Discussion of the Paper “SPE-187038-MS: Fracture Closure Stress: Reexamining Field and Laboratory Experiments of Fracture Closure Using Modern Interpretation Methodologies”

Mark McClure

ResFrac Corporation

April 15, 2019

Figure 2: Reproduction of Figure 6c from Craig et al. (2017). Tiltmeter measurements during reopening in Injection 4b from the MDX field demonstration project.

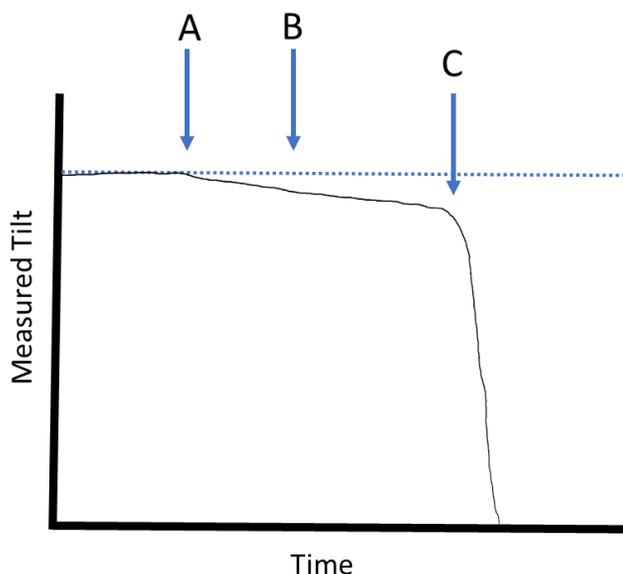
Because of how Craig et al. (2017) plot the data, interpretation is hampered by uncertainty regarding injection rate. However, even if we assume that injection rate is constant over time, the data does not support their conclusion. Because the paper is copyrighted, the figure is not reproduced below. Instead, the results have been reproduced from their Figure 6c by tracing over the curve with a stylus. The tilt is measured as 'negative' so the curve goes down as the crack opens. The figure from Craig et al. (2017) also shows the concurrent fluid pressure, but in Figure 2, only tilt is shown, for clarity. Figures 6a and 6b from Craig et al. (2017) are qualitatively the similar, and so are not reproduced.

There are two points with apparent deflection in tilt: Points A and C. Point A corresponds to 2500 psi, lower than the predicted reopening pressure from either the tangent or compliance methods. Point C corresponds to the point when pressure is equal to the closure pressure from Injection 4a, as interpreted by the compliance method (3200 psi). The fluid pressure at Point B corresponds to the reopening pressure predicted by the tangent method (2900 psi). After Point C, the tilt goes off the scale of the graph as the fracture opens further.

Craig et al. (2017) claim that the data in Figure 2 confirms the tangent method pick that stress is equal to 2900 psi (Point B). However, the curve is straight at Point B. The curve deflects at Points A and C. There is not a discernible deflection at Point B.

Fractures have roughness, and joints have a nonnegligible compliance and ability to store fluid, even when their walls are still in contact (Barton et al., 1985; Jaeger et al., 2007). Thus, some fluid will seep into the fracture prior to the full separation of the walls, followed by a much larger change in aperture once the walls fully separate. Point A corresponds to the point where nonnegligible amount of fluid seeps into the fracture (while the walls are still in contact). Point C may be the point corresponding to full separation of the fracture walls, but again, a true interpretation is impossible because of how the data is plotted.
